Note no.: Div./sect.no.-year-no. FDIV/23-82-01	Date: 28.06.82
Title: CNRD 13-2 TENSION PILE STUDY REVIEW OF ERTEC'S REPORT NO. 82-200-1, "SITE INVESTIGATION AND SOIL CHARACTERIZATION STUDY AT BLOCK 58, WEST DELTA AREA, GULF OF MEXICO"	
Written by: Tore J. Kvalstad

REVIEW OF ERTEC'S REPORT NO. 82-200-1, "SITE INVESTIGATION AND SOIL CHARACTERIZATION STUDY AT BLOCK 58, WEST DELTA AREA, GULF OF MEXICO."

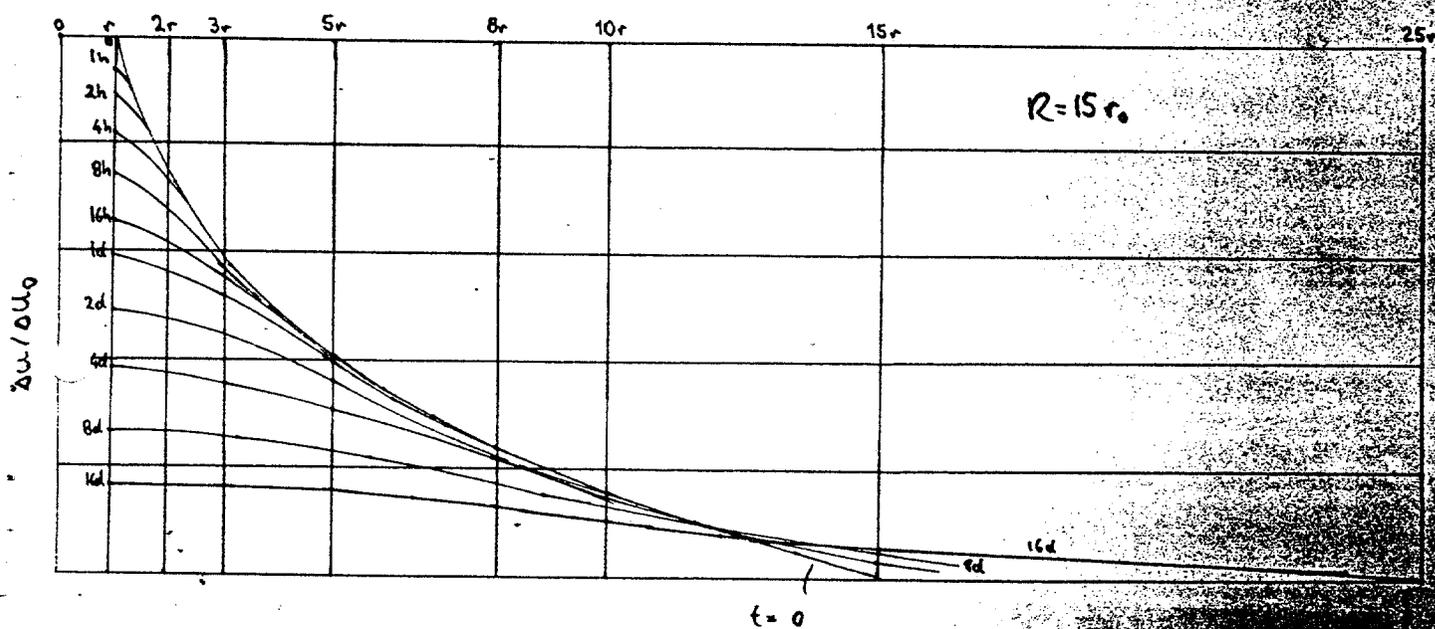
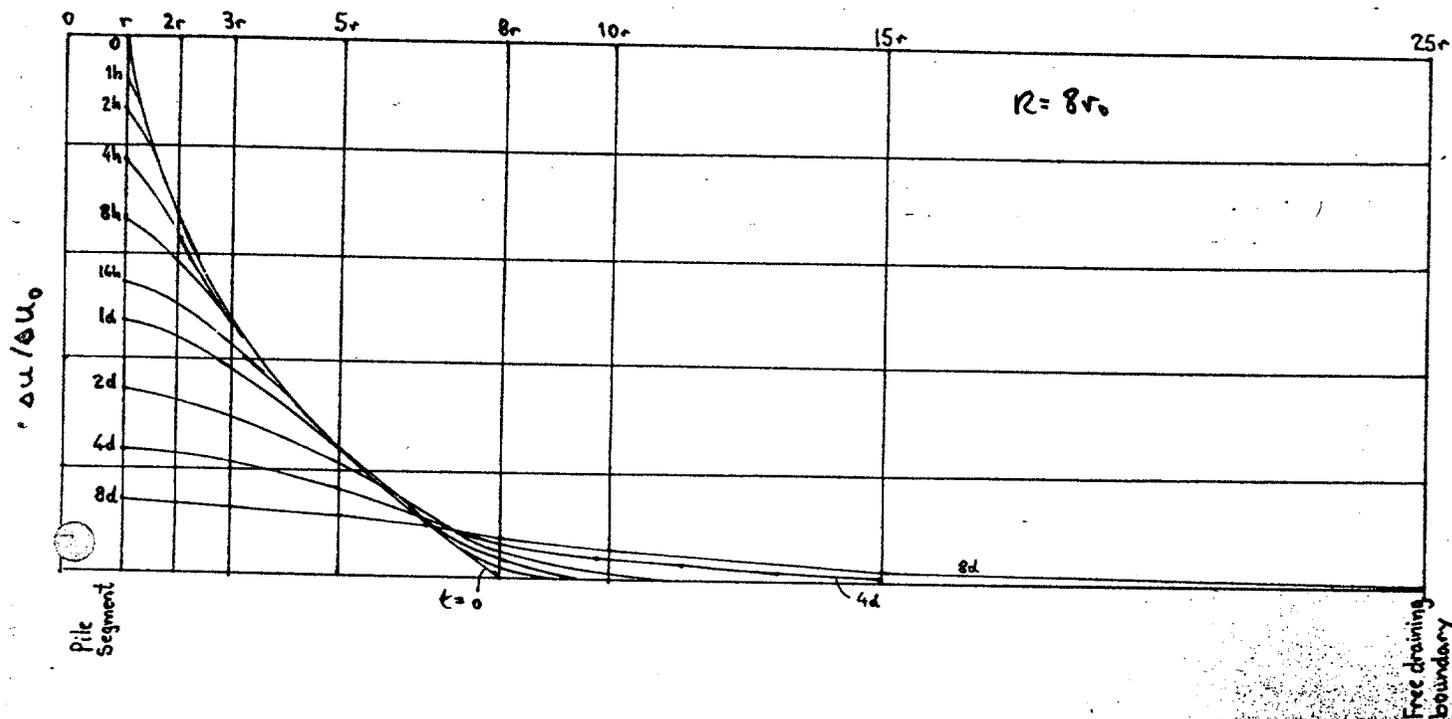
Based on our evaluation of the set-up process around the pile segments using an axisymmetric FEM program, the set-up time required to reach 90% dissipation of excess pore water pressure at the pile surface can be considerable and in the range of 2 to 6 weeks for the c_v -values determined by McClelland and NTH. If Ertec's values turn out to be more representative a 90% dissipation of excess pore water pressure could take place within 4 days to 2 weeks. See enclosed Figures 1 and 2.
